TECHNICAL INFORMATION

67072

Subject	▶ Change of DC Motor
For Models	▶ 6010D, 6012D, 6015D, 6070D, 6071D, 6072D, DA301D, DA3000D, M002, M003, M014
Country	▶ All countries
Description	▶ DC Motor has been changed as shown below.

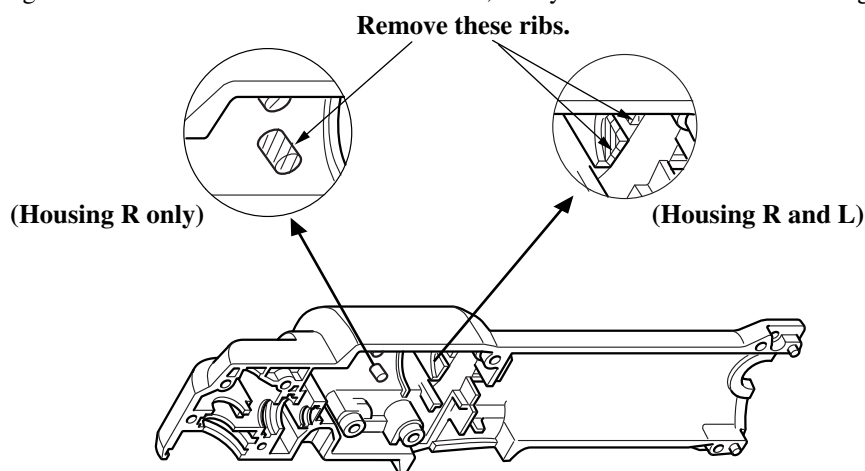
▶ Current	▶ New

When installing new DC Motor on DA301D or DA3000D, always remove the ribs of Housings R and L shown below.
